## **IMPORTANT SAFETY RECALL – 14V-xxx**

## SN-611-14

SUBJECT: *Muncie PTO switch leakage on Ford 6.8L Gas engines*

Re: Ford Super Duty Chassis with 6.8L gas engine and Muncie FR67 Series PTO

Switch to inspect for leakage

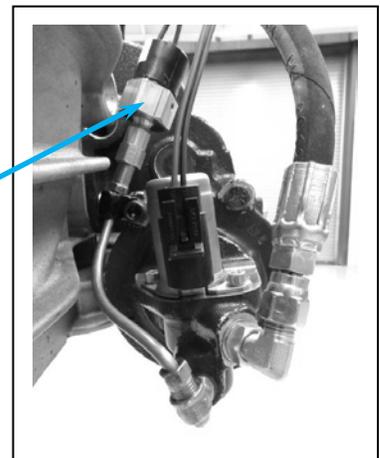
Immediately inspect affected vehicles for any oil leakage from the PTO switch and the condition of the thermal blanket around the exhaust pipe in front of and below the PTO. If the switch is leaking immediately remove the vehicle from service and replace the switch. Also inspect the thermal blanket around the exhaust pipe in front of and below the PTO for damage. Replace the thermal blanket if damaged.

Note: The PTO is located on the side of the transmission. The switch is located on the front of the PTO.

If there is no visible leakage and the thermal blanket is in good condition the vehicle can be used provided the switch is inspected for leaks weekly. Install the Switch Kit at the next service interval, not to exceed 90 days.

If any leakage is detected do not operate the vehicle and replace the switch immediately. Contact your nearest Muncie Power Products Dealer or call Terex Utilities at the contact information below.
